Addendum No. 1

RE: Contract ID C202602

Iredell County (I-3819A)

I-40/I-77 Interchange, I-40 From West Of SR-2003 To SR-2158 and

SANITARY SEWER
Bore Under Paved Roadways

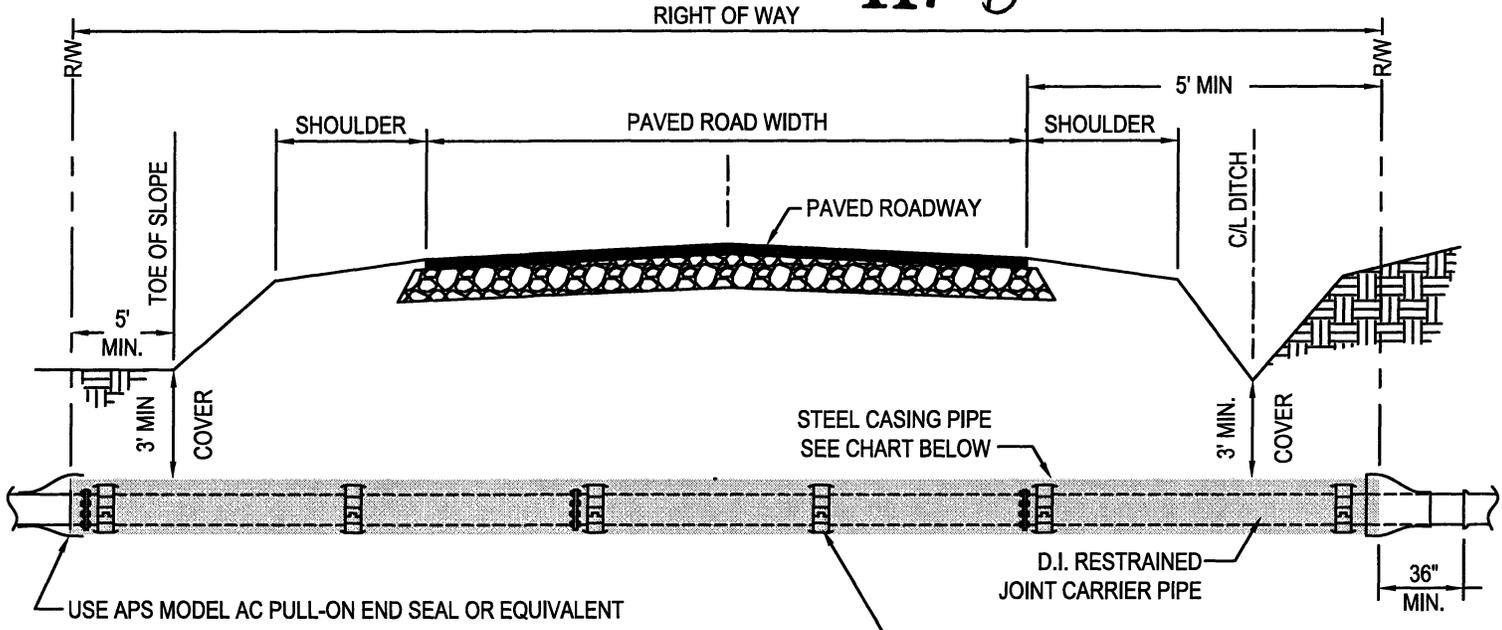
Trenchless installation by Bore and Jack under Paved Roadways shall be as indicated on City of Statesville Standard Detail S-1, dated May 2010. Where carrier pipe is 30-inch nominal inside diameter, casing pipe under roadway shall be minimum 41-inch nominal inside diameter. Carrier pipe shall be ductile iron restrained joint pipe.
